Re: Responses to Reviewer 1 (Dr. Fabio Crameri) Comments

Date: 19-Feb-2025

Re: Responses to Reviewer 2 (Dr. Richard Westaway) Comments

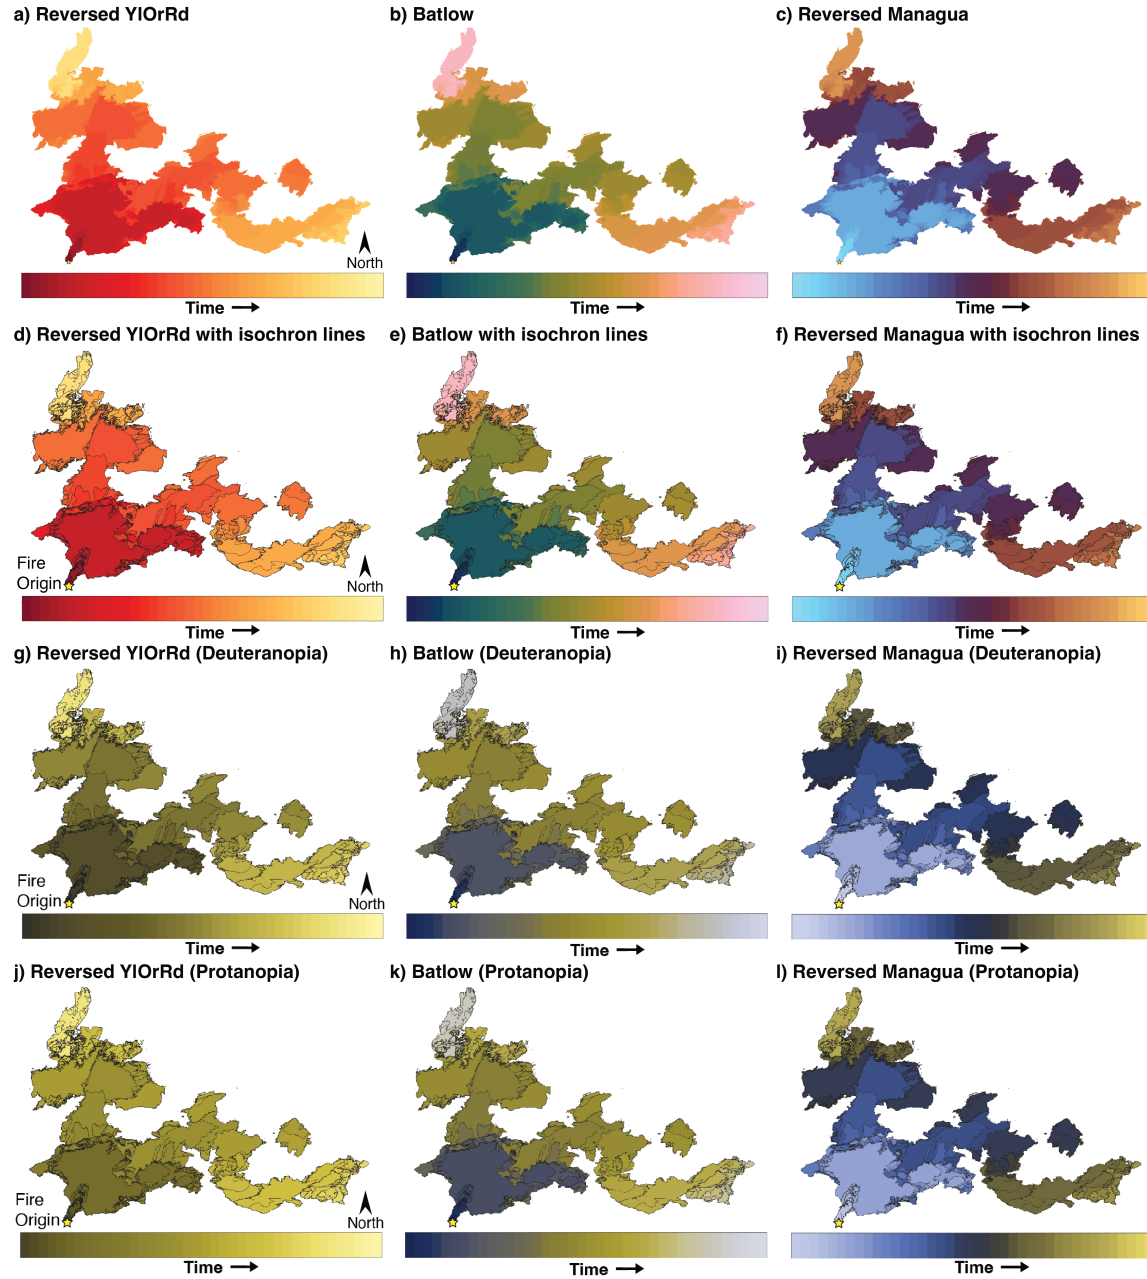
I have one major suggestion: Would simulating and providing colour-vision deficient appearance (as is done for figure A1), and maybe even greyscale conversion, of figure 1 be useful for the purpose of the manuscript? – I think it would and attached some simulations (based on Brettel et al., 1997; happy to share adjusted figures for the author). That way, it would also become more clear that Turbo is not suited for a scientific application (repeated colours along the scale).

This is visible in Figure 1, where the neighbouring colours in the blueish parts of the color bar clearly differ more strongly than e.g., in its greenish parts.

Figure 1: Given that many people tend to look at figures mostly, these days, the figure caption could be a bit more descriptive to be more helpful: for example, explain that these are recommended colour maps, and what techniques are used in (b,d,f) to increase accessibility.

This is an excellent suggestion, which was also provided by reviewer 2, thus highlighting the value of performing the colourblindness simulation. I have followed this suggestion as it will

more strongly help to make the case of the manuscript as both reviewers noted. To keep the figure to a reasonable size, I opted to include the three colourmaps with no isochron (top row; given this is a noted suggestion in the main text) and with isochrons (next row) and show two colour-vision deficient appearances in the following two rows (deuteranopia and protanopia, respectively). Following the suggestion of reviewer 2, I include only one burn area (the Dixie Fire) in the main manuscript and moved the second example (the Rim Fire) to the appendix. Since the figures were becoming small, I put greyscale images in the appendix and added a note to the text that the sequential maps work well for greyscale but the diverging Managua requires a fire origin and/or labeled isochrons to orient the direction of fire progression. New text:

"While the sequential colourmaps "YlOrRd" and "Batlow" print well in black and white, the diverging "Managua" requires additional annotation (e.g., an origin point or labeled isochrons) to orient readers to the direction of fire progression."

Agreed, I have added additional description pursuant to the reviewer's suggestion to improve the value of the caption text. Please see the revised captions associated with the revised Figure 1 and new Appendix Figure 2.

Figure 1: Revised Figure 1 of the 2021 Dixie Fire (note the same version of the Rim Fire is now shown as Figure B1. The revised caption is explained in response to the next comment.

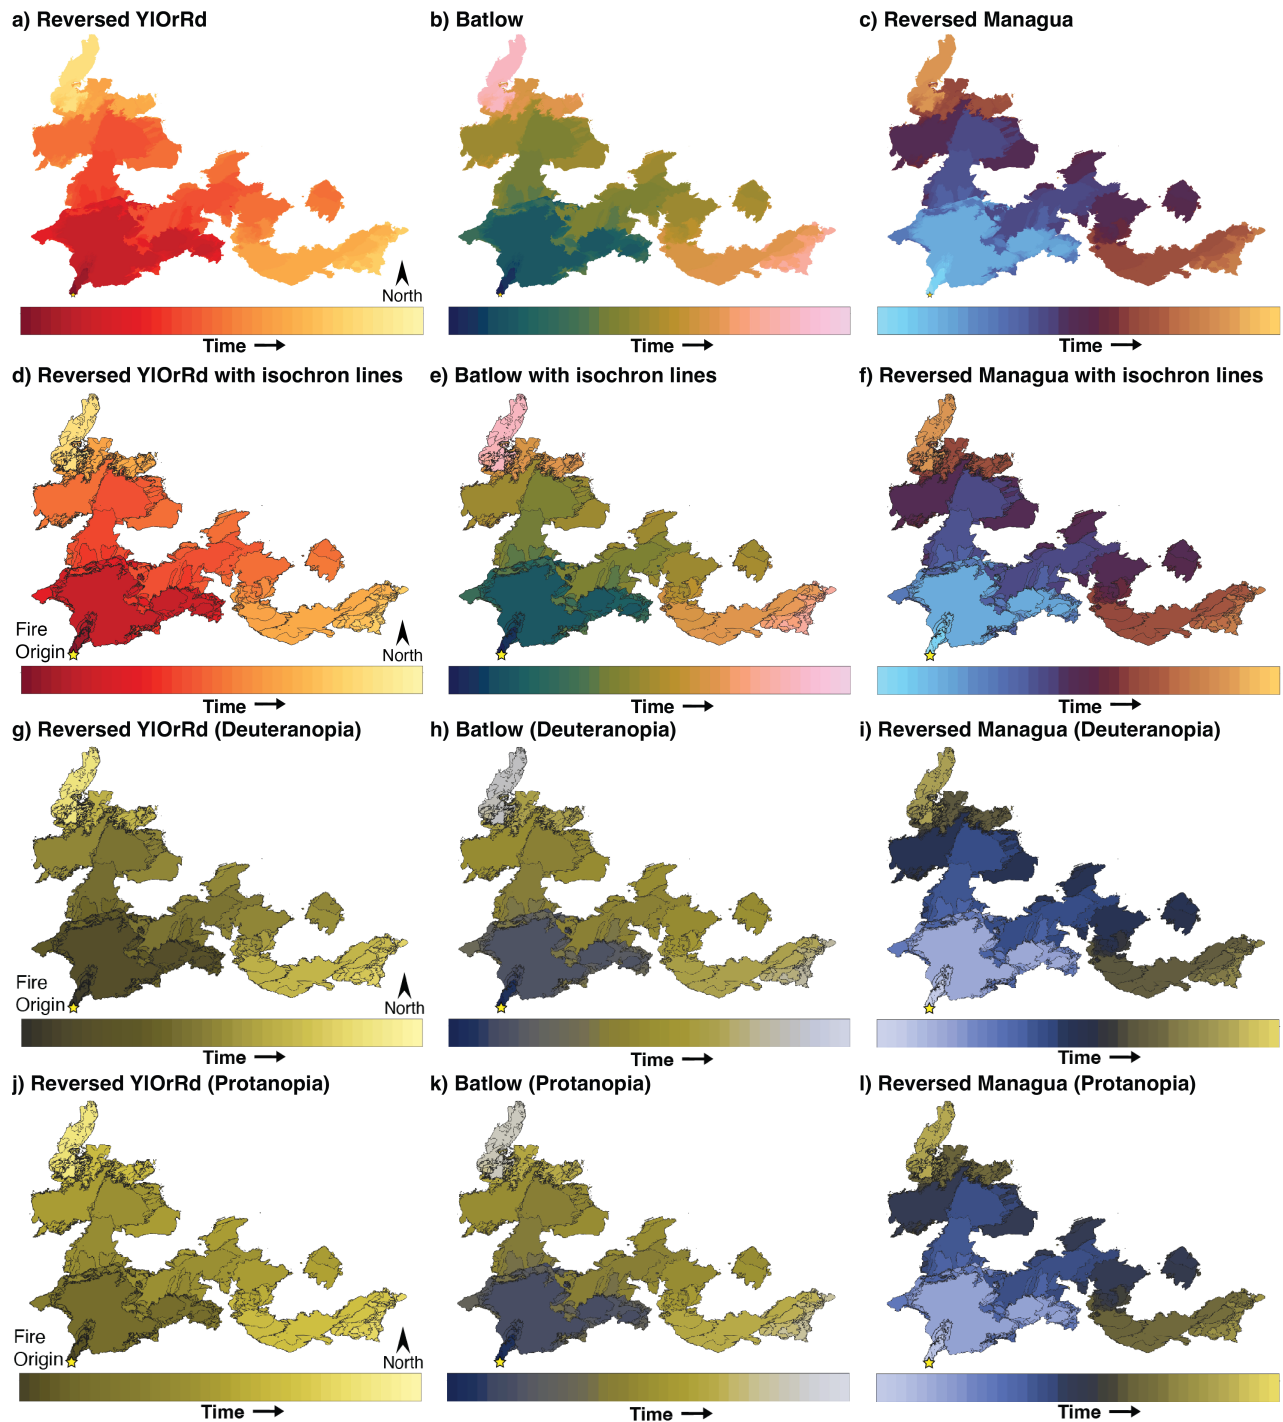
This figure is intended to illustrate the importance of colormaps for FPMs, and also serves to demonstrate some different color options that are available. However, I find the choice of datasets and colormaps as currently presented is somewhat muddled and suggest that an alternative set of panels might more clearly support the narrative. Currently, Figure 1 presents fire perimeter data from two fire events, demonstrates four different colormaps as well as showing the visual impact of including isochrons. However Figure 1 does not currently include any color blindness simulation or black and white printing challenges (as are shown in Figure A1 for other fire progression mapping examples).

While not possible to show every permutation, I would suggest simplifying what is being shown for example by separating (or only showing one of) the two fire events – plus adding in some examples of colour-vision deficient appearance – such that 12 panels are shown for each fire event

(3 panels wide x 4 panels tall), with the panels progressing more logically and allowing easier comparison: 1a Rim Fire Turbo; 1b Rim Fire Turbo with isochrons; 1c Rim Fire Turbo with color blindness simulation; 1d Rim Fire Batlow; 1e Rim Fire Batlow with isochrons; 1f Rim Fire Batlow with color blindness simulation; 1g Rim Fire reversed YlOrBr; 1h Rim Fire reversed YlOrBr with isochrons; 1i Rim Fire reversed YlOrBr with color blindness simulation; 1j Rim Fire reversed Managua; 1k Rim Fire reversed Managua with isochrons; 1l Rim Fire reversed Managua with color blindness simulation. Then I would suggest repeating for the Dixie Fire, i.e.: 2a Dixie Fire Turbo; 2b Rim Fire Turbo with isochrons; 2c Rim Fire Turbo with color blindness simulation; and so on...

Recognising the figure constraints of the GCInsights format, and given that the full 24 panels would be near impossible to display together, I would advocate illustrating perhaps one of the fire events in the main body text (Figure 1 a-l) and moving the other to the Appendix (new Figure A2 a-l). If this is still felt to be too many panels to communicate clearly, my instinct and preference would be that color vision deficient appearance is more important to illustrate (i.e. has a larger effect on visual communication) than the presence/absence of isochrons, which would eliminate the need for four panels per fire event.

The figure captions should also be changed accordingly, and I would suggest expanded to explain each panel more fully.

13. p3, Figure caption: I suggest that the caption is expanded to include more details about what is being shown in Figure 1. However please see my general comments above for further suggestions about Figure 1.

Thank you for the excellent and thoughtful ideas to adjust Figure 1, which reviewer 1 also noted as a major concern. By merging both of the reviewer suggestions, I have revised Figure 1 to now show a single fire (the Dixie Fire) and to include color vision deficient simulations (deuteranopia and protanopia, respectively) for three 'better' colormaps. Following the suggestion here, I include the second fire (the Rim Fire) as an additional appendix figure.

I wish to note that following suggestions from reviewer 1, the "Turbo" colormap has been removed and now both the revised Figure 1 and new Appendix Figures B1 and C1 to show the same colormaps throughout for the two fires (Figures 1 and B1) and for greyscale simulation (Figure C1). At this stage, I opted to include the isochron comparison as I feel this is an important point made in the text as well (to help delineate the "just noticeable differences" that arise as discrete colormaps grow in the number of steps shown to begin to approach a continuous colormap. The new figures are shown below; note these include isochrons and the black/white simulation is included as an appendix figure; the diverging nature of the Managua option limits its ability to be assessed without labeled isochrons or without a fire origin point, this is now noted in the text. Also per the next comment, please note additional details are provided in the captions:

Caption for revised Figure 1: *“(a-c) Daily fire progression maps of the 2021 Dixie Fire using three colourmaps that are accessible for colour vision deficient viewers and demonstrate a physically-intuitive sequential progression through time (i.e., older shown by cooler cooler colours and newer by warmer colours. (d-f) As in (a-c) but including isochrons. (g-i) Maps in (d-f) with deuteranopia (green-blind) colourblindness simulation. (j-l) Maps in (d-f) with protanopia (red-blind) colourblindness simulation. The yellow star denotes the fire origin location.”*
